PUBLIC SCOPING REPORT

Arica and Victory Pass Solar Projects

January 2021

9. Microphyll Woodland Should Be Avoided.

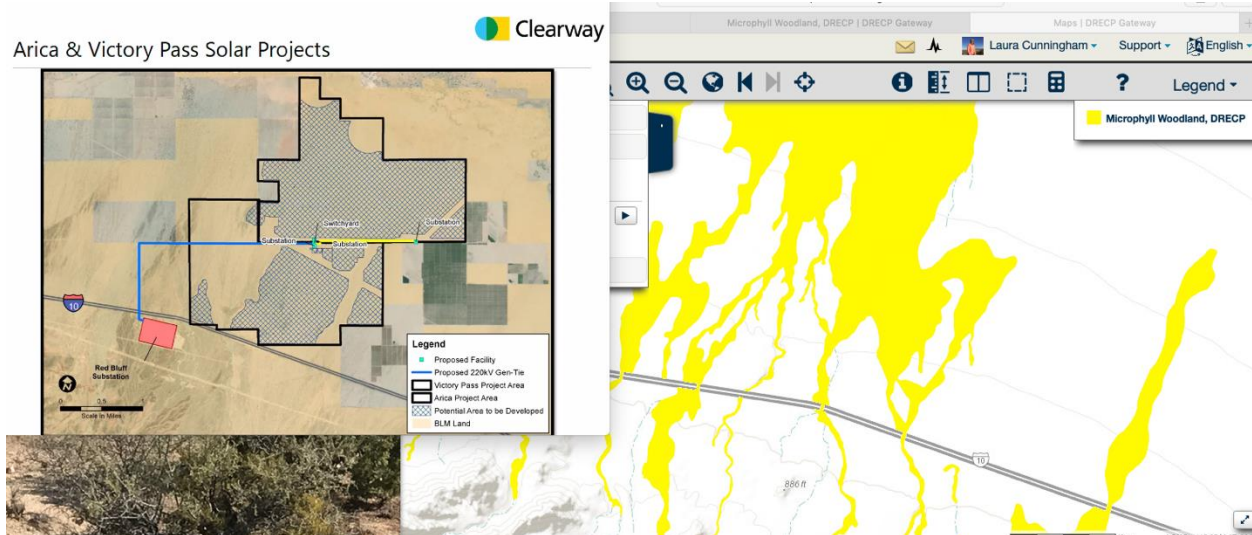
DRECP maps of microphyll woodland at Databasin.org do not appear to match up with applicant proposed solar project maps shown on the BLM-hosted Zoom meeting. This should be reconciled.

Screenshot of the Arica and Victory Pass Solar Project proposals with avoidance areas, compared with mapped microphyll woodlands on approximately the same mapped site from the DRECP database. These do not appear to match, and the project sites may contain more high-value resources than the public meeting suggests.

Figure 1 Red shading indicates area in direct line of sight at ground level of the Arica/Victory Pass projects

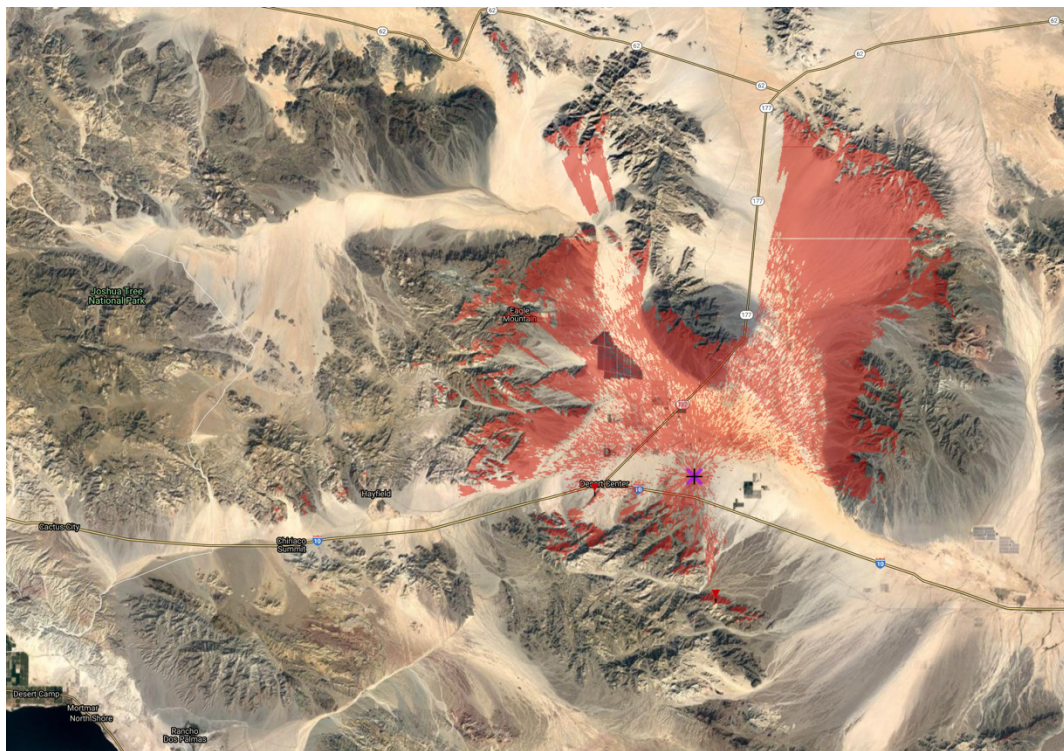
The EA/EIS should examine the effects of these developments on the viewshed in the area, especially with regard to further industrialization of the landscape visible from both the Park and nearby wilderness areas. Our rough calculations suggest that the projects will

be visible not only from a large portion of the nearby Eagle and Coxcomb mountains in the Park, but from a wide swath of the Palen-McCoy Wilderness to the east, as well as within the Chuckwalla Mountains Wilderness. (See included image.) The projects would seem even to be potentially visible from the southern end of the Sheep Hole Mountains in Sheephole Valley Wilderness roughly 25 miles northwest of the project site, though that visibility would perhaps be limited to certain conditions conducive to glint or glare. Especially in the context of the pandemic and its resulting increase in public interest in visiting wild spaces for rest and restoration, the EA/EIS should carefully consider the effects of this development as it adds to the overall change in the appearance of the surrounding landscape from nearby wilderness areas.
